PORT & MARINE SERVICES

ADDENDUM NO. 1

MARGARET STREET FIRE PUMP BUILDING KEY WEST HISTORIC SEAPORT ITB #22-008

BID SCHEDULE:

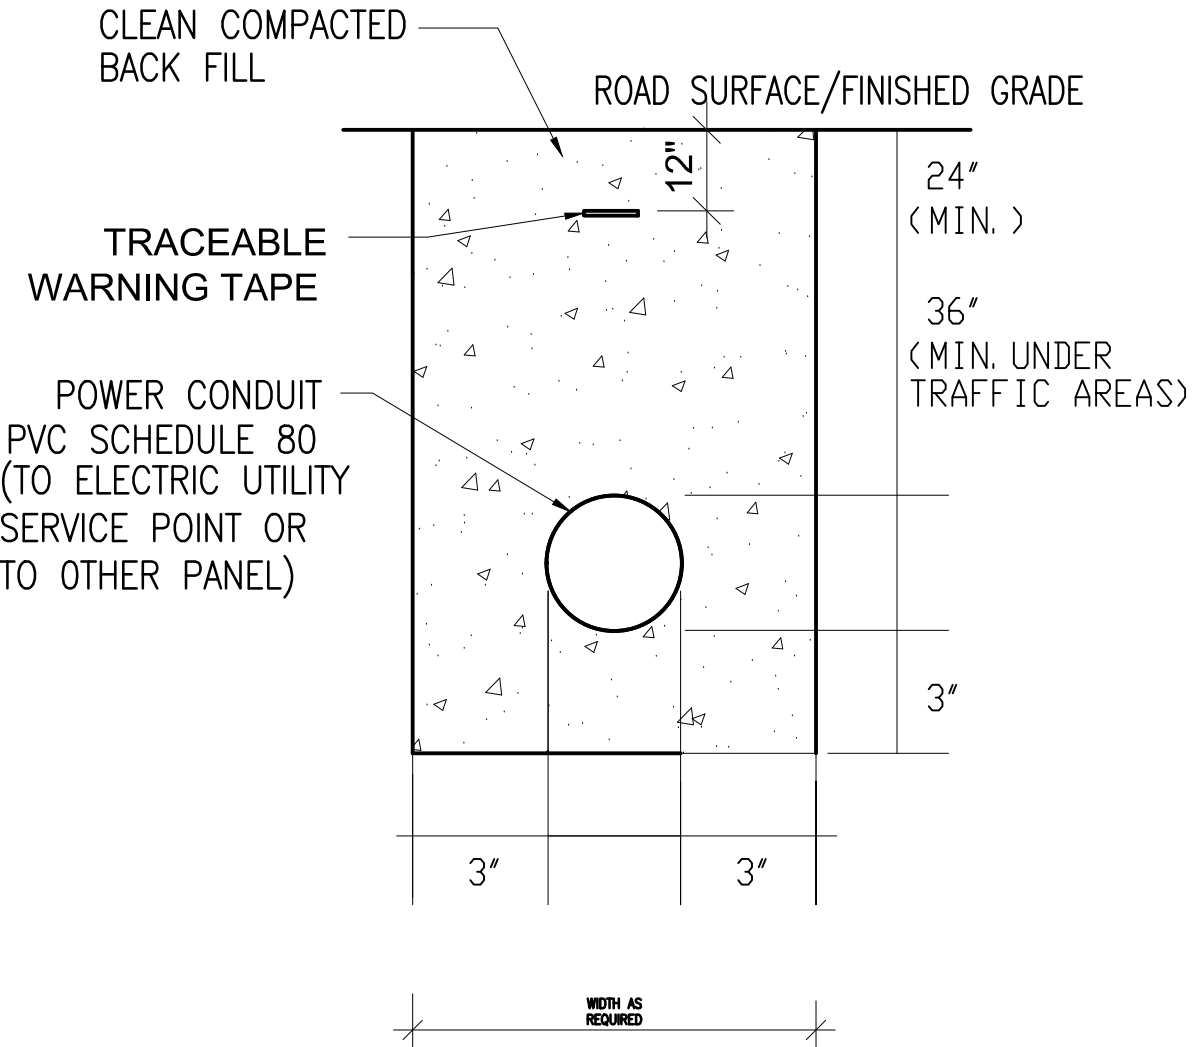
DELETE Bid Schedule and REPLACE with attached
